# PARK CITY MUNICIPAL CORPORATION PLANNING COMMISSION

September 14, 2016

Treasure Hill Conditional Use Permit, Creole Gulch and Town Lift Mid-station Sites – Sweeney Properties Master Plan <i>Review of proposed density and public hearing</i> <i>Consideration of Motion to Continue Public Hearing to October 12, 2016</i>	PL-08-00370 <i>Planner</i> <i>Astorga</i>	79
--	---	----

### **1. Treasure Hill Conditional Use Permit, Creole Gulch and Town Life Mid-Station Sites – Sweeney Properties Master Plan. (Application PL-08099370)**

*The following is a portion of the Creole Height diagram from the MPD exhibits page 22.*

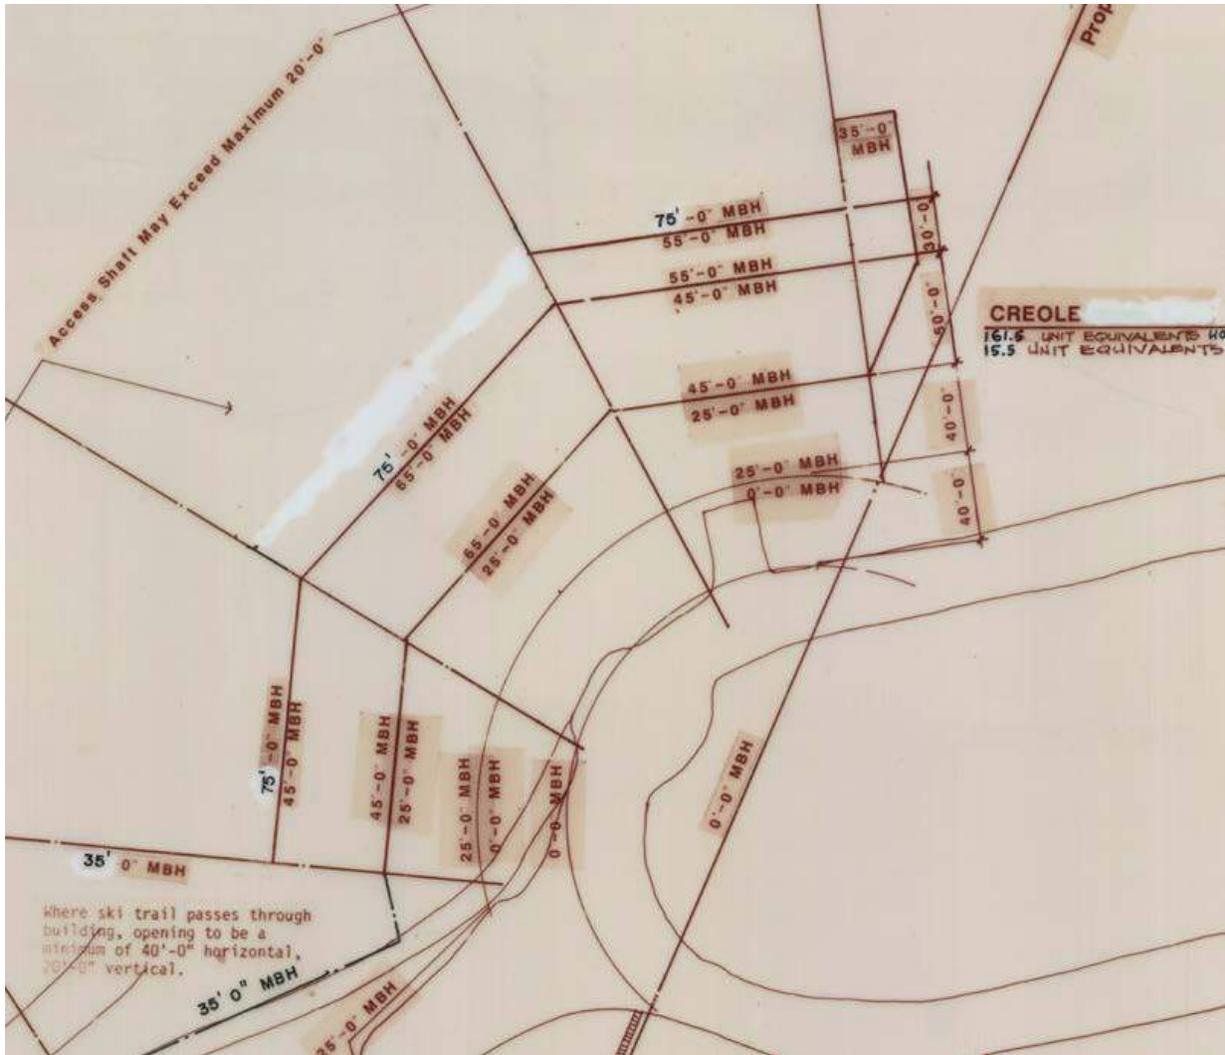
*The 1986 MPD approval set standards for increased density and increased height on the site. The MPD set height envelopes over the site which increased the allowed height from the front to the rear lot lines. The area closest to the front lot line along the Lowell Avenue/Empire Avenue switchback was set at a 0' maximum building height. The maximum building height increases in steps from the front property line. Maximum elevations were also set within the MPD. The mid-station maximum elevation was set at 7420 feet and 7275 feet for Creole. The current application complies with the height requirements set forth in the MPD, yet the design modifies existing grade well beyond the anticipated amounts shown in the exhibits of the MPD.*

*This MPD exhibits designated the areas that the buildings could be built within the development parcel. The second guiding document is the conditions of approval for the MPD in which maximum height envelopes were defined. The following is from the findings within the MPD approval.*

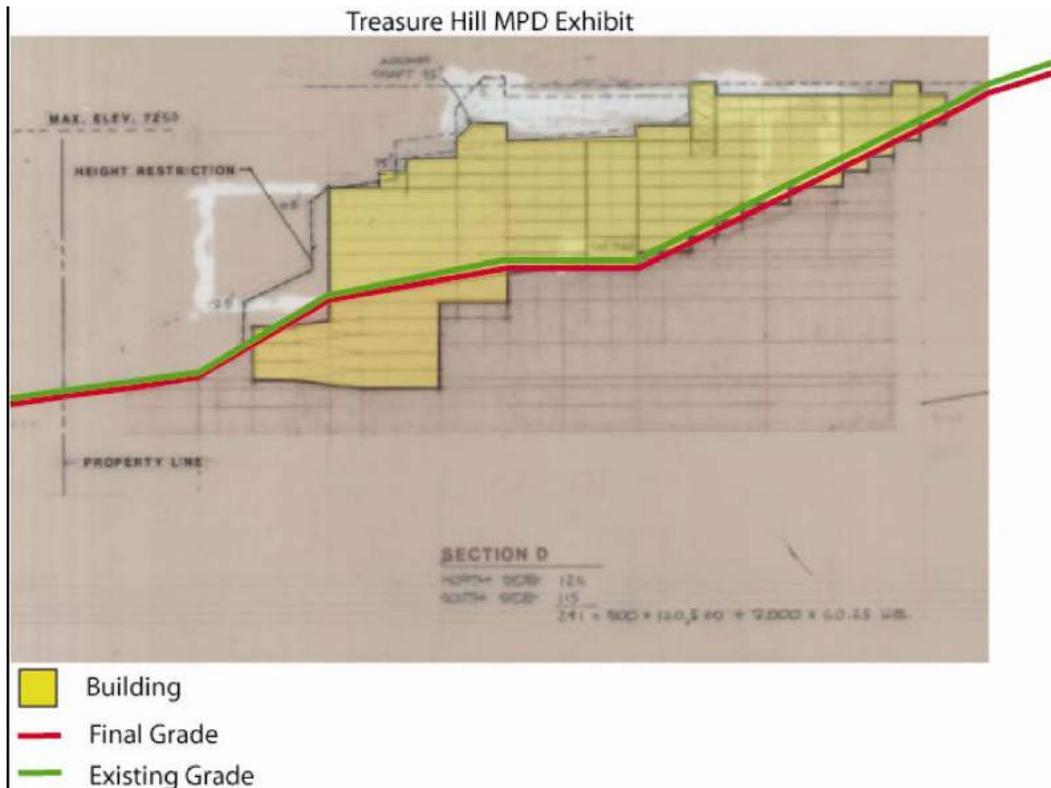
*Staff finds that the excess square footage included in the project that is influencing the building massing and bulk. The building mass and bulk is also influencing the orientation of the buildings on the site. The original MPD exhibits were to be utilized as guiding documents. The following is from Exhibit 19 and is an architectural section of one of the buildings on the Creole site.*

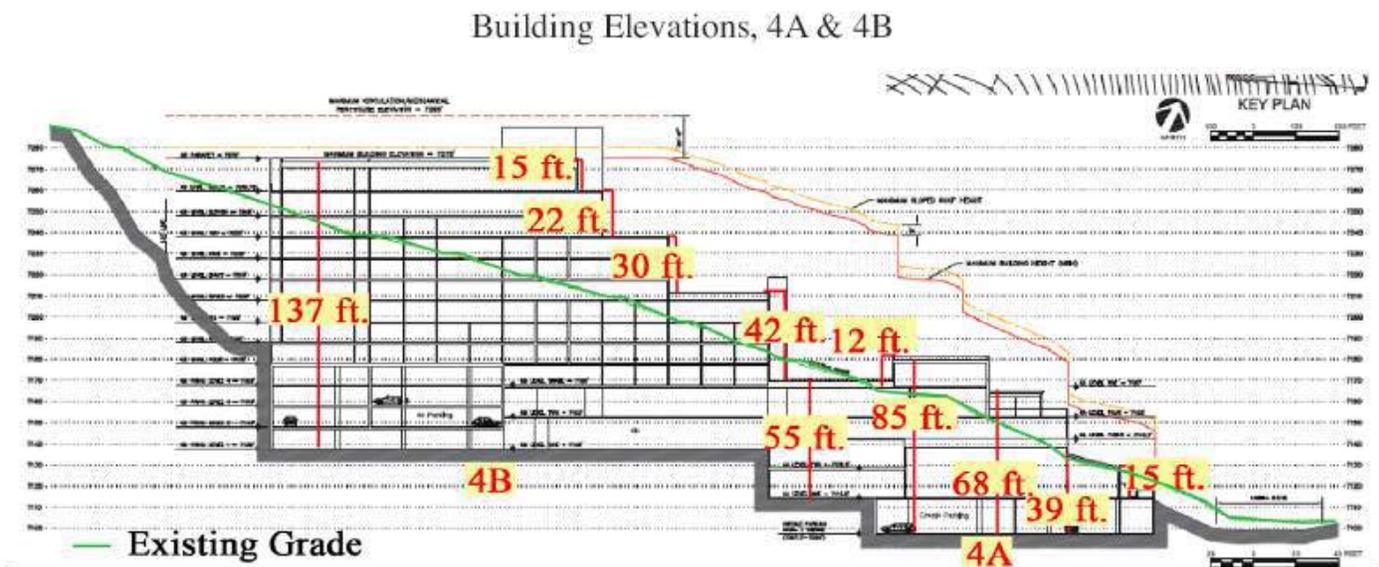
The building steps with the grade on the site and manages to keep final grade (after construction) close to existing grade (pre-construction). The majority of the area shown below grade is for the parking.

The current application places more massing and bulk below the existing grade. Not only is the massing placed below the existing grade, the grade is then altered dramatically creating taller building walls, taller retaining walls, and greater massing. The following is a section through Creole site plan of the project. The green line is existing grade. The red line is the maximum height envelope. By creating a lower final grade, the buildings appear taller and the bulk and massing becomes larger. The pedestrian walking through the project will experience higher building walls due to the change in final grade. Also, the view from other parts of town (Exhibit B) is of building with greater massing due to the change in final grade from existing.

Staff expects grade to be altered on the unique, steep site in order to accommodate the amount of density allowed on this site, exterior circulation, and parking. The extent to which existing grade is being altered is far beyond the anticipated amount within the MPD and is creating greater impacts to mass and scale. The MPD was clear that the height measurement would occur from natural grade and were within height envelopes. By modifying natural grade over 100 feet, the height envelopes do not serve the purpose for which they were created.

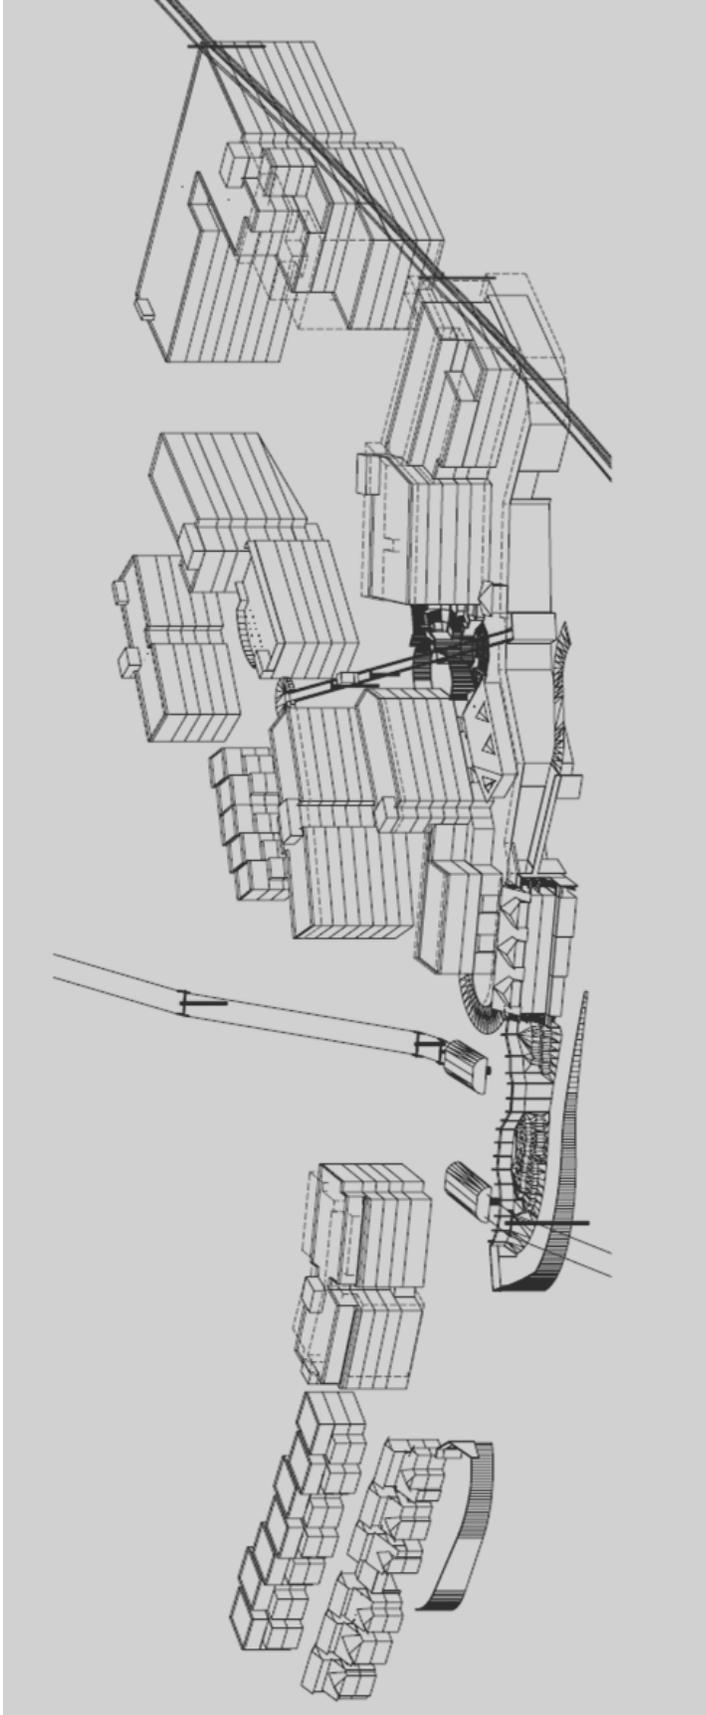
Compatibility with the surrounding structures in mass and scale must be considered within the rights of the Sweeney master plan. The master plan created an area of greater height allowances and density next to a historic neighborhood with low height and medium density. The MPD essentially created a new zone with height envelopes and greater density adjacent to the HR-1 zone, Estate zone, and open-space. The Planning Commission must find compatibility with surrounding structures within the higher density already approved.

Staff acknowledges that it will be difficult to achieve a project massing that is similar to the existing neighborhood context given the previously approved density and volumetrics set forth in the MPD. The Sweeney Master Plan anticipated the difficulty of designing higher density adjacent to the historic district. The following is from the analysis section of the 1985 Master Plan staff report:

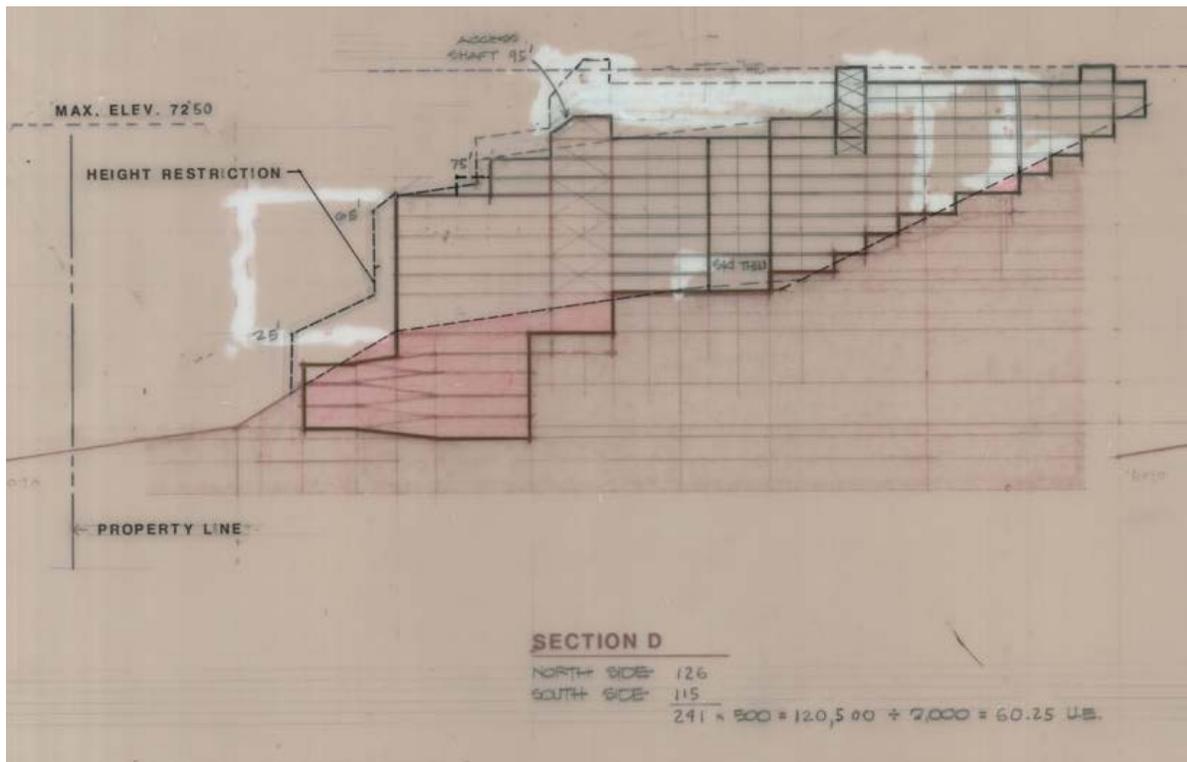
*The proposed design requires a very large excavation and re-grading of the entire site. The project is located on the mountain side on steep topography. The impacts to the slope and existing topography are substantial and unmitigated. The project as designed will create a very large hole on the site. The project does not step with the natural topography of the site. As discussed previously, staff finds the project as designed is not in compliance with the concept approved by the City Council during the 1986 Master Plan approval. The exhibits within the master plan showed the building volumes stepping with the existing grade with the exception on the underground garage.*

*By stepping with the natural grade, there is less excavation. The exhibits within the master plan are guiding documents. The exhibits show minimal impacts on excavation.*
